ALERT SERVICE BULLETIN

ASB 210-23-18

MODEL AFFECTED: 210

SUBJECT: TENSION ROD ASSEMBLY P/N 205-030-249-009
OR 205-030-249-013, INSPECTION OF.

FIGURE 1. Inspection requirements.

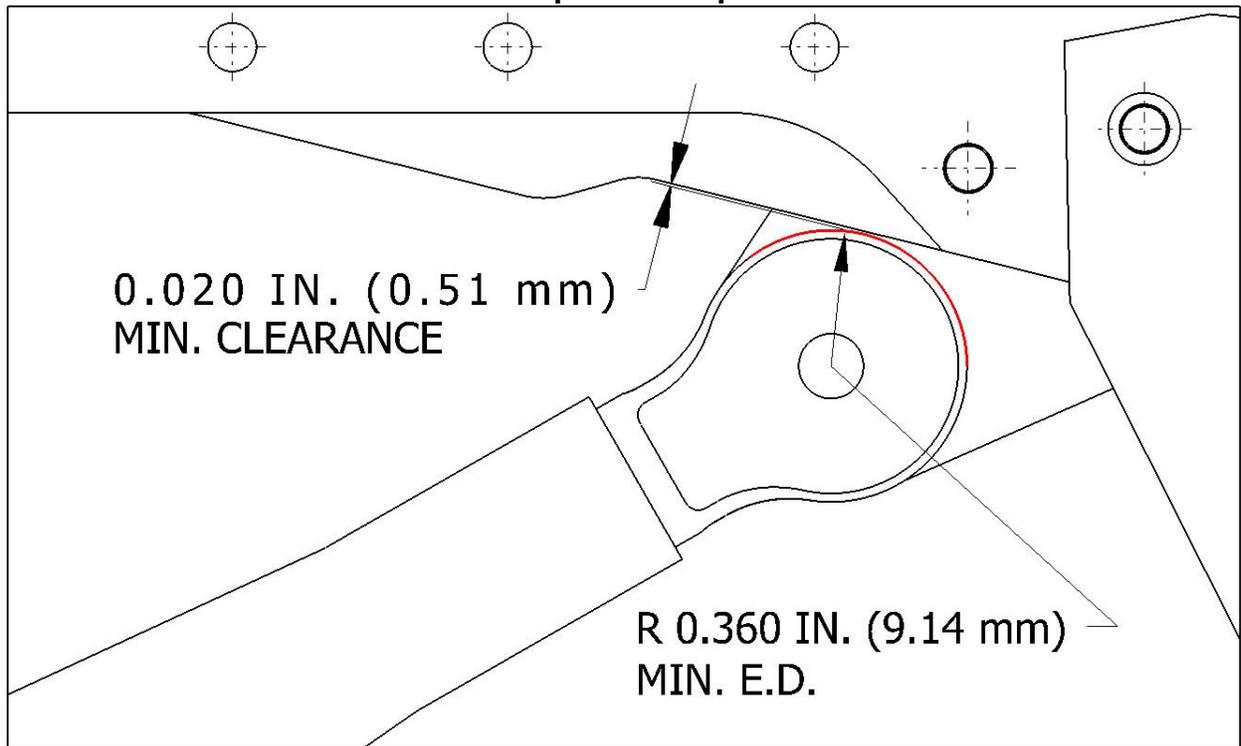
2. Inspect the forward end (upper attachment location) of the tension rod assembly as follows:
 - a. Inspect the outboard side of the tension rod assembly rod end for a possible over trimmed condition. Minimum acceptable radius dimension measured from the bolt hole center is 0.360-inch (9.14 mm) edge distance (E.D.) (Figure 1). Removal of the attachment bolt may be required to perform this measurement. Record

- b. Check for fouling or low clearance conditions between the rod end and the structure (cap, web, angle). Minimum acceptable clearance is 0.020-inch (0.51 mm) (Figure 1). Record findings.

FIGURE 2. Inspection requirements

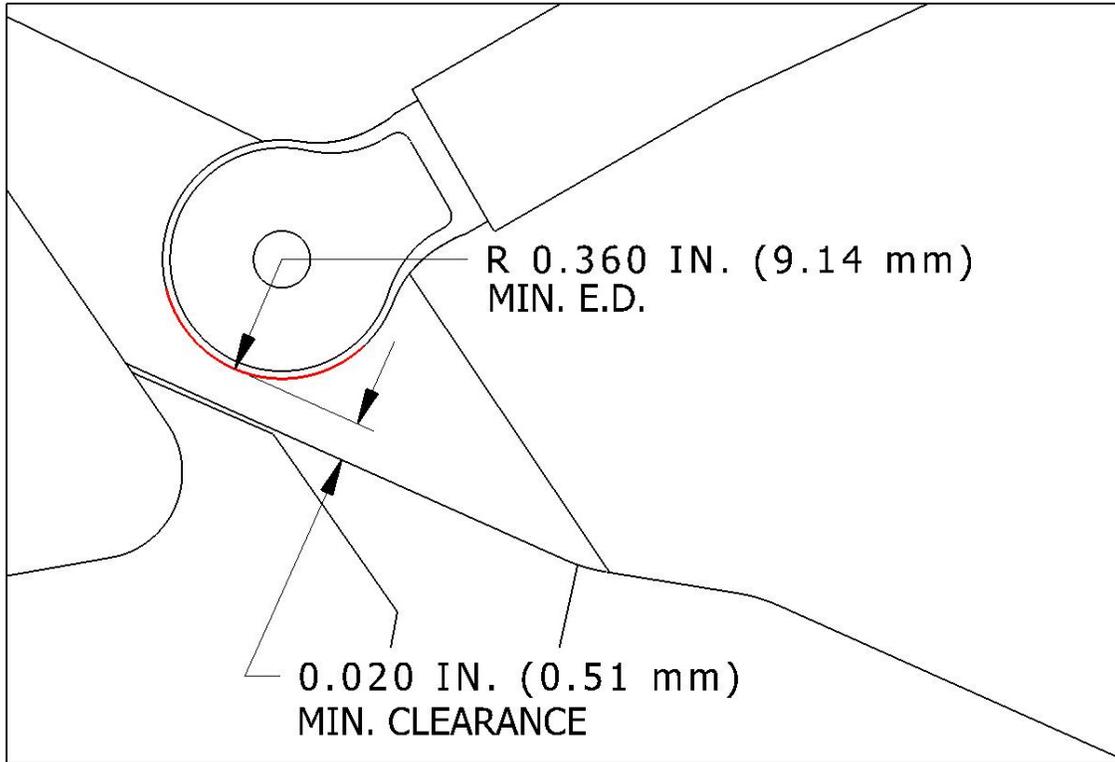
3. Inspect the aft end (lower attachment location) of the tension rod assembly as follows:
 - a. Inspect both sides of the tension rod assembly rod end for a possible over trimmed condition. Minimum acceptable radius dimension measured from the bolt hole center is 0.360-inch (9.14 mm) edge distance (E.D.) (Figure 2 and 3). Removal of the attachment bolt may be required to perform this measurement. Record findings. During reinstallation of hardware, if required, tighten the nuts IAW appropriate instructions.

- b. Check for fouling or low clearance conditions between the rod end and the structure (cap, web) on the outboard side and the fillet radius on the inboard side of the fitting. Minimum acceptable clearance is 0.020-inch (0.51 mm) (Figures 2 and 3). Record findings.

FIGURE 4. Tension rod assembly proper installation verification.

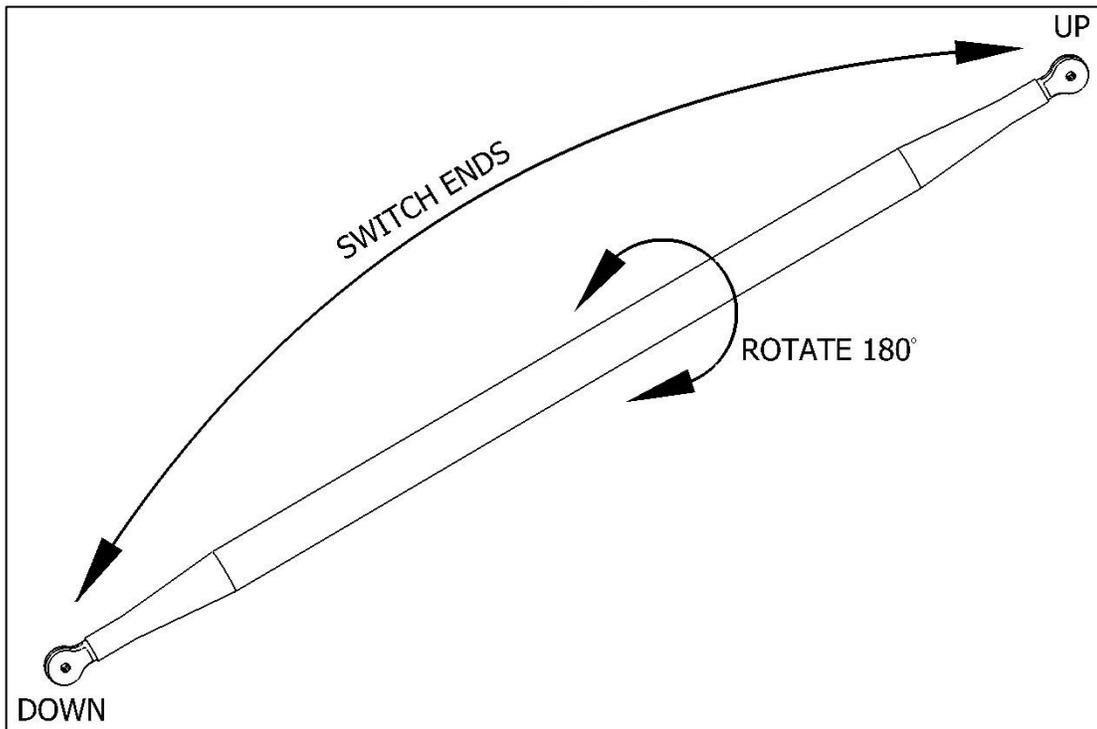
1. If a fouling or a low clearance condition exists, the tension rod assembly may have been incorrectly installed. Prior to trimming the rod ends, remove the tension rod assembly (step 1.a.) and try different orientations by rotating and/or switching ends

to obtain the best possible fit (Figure 4). If proper clearance dimensions as defined in PART I cannot be met, proceed with step 3.

FIGURE 5. Rework requirements
KEEP 0.280 IN. (7.11 mm) MIN. E.D.
FOR FASTENERS (CAP, WEB, ANGLE)

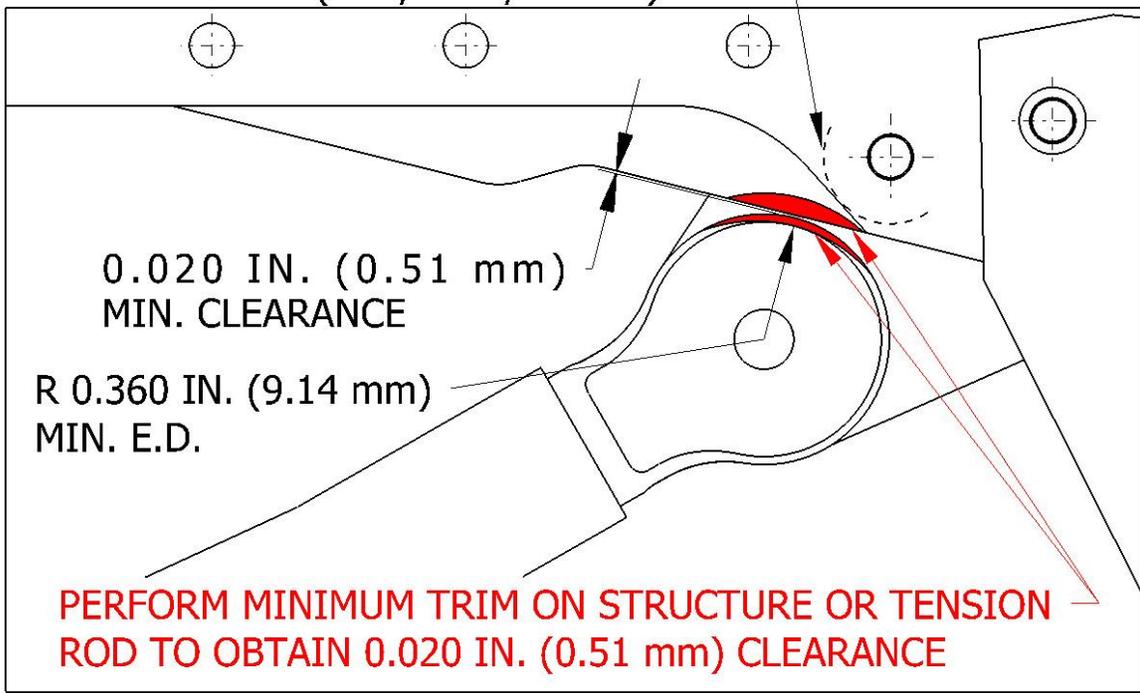
3. Temporarily reinstall tension rod assembly. Mark the minimum material removal required on the affected rod end and/or structure attachment points to obtain the required clearance. (Figure 5 for the upper bolt. Figures 6 and 7 for the lower bolt.)

5. Trim and deburr previously marked material on the affected rod end and/or structure attachment fitting. Ensure the inspection criteria defined in **PART I** are respected (Figures 1, 2, and 3).
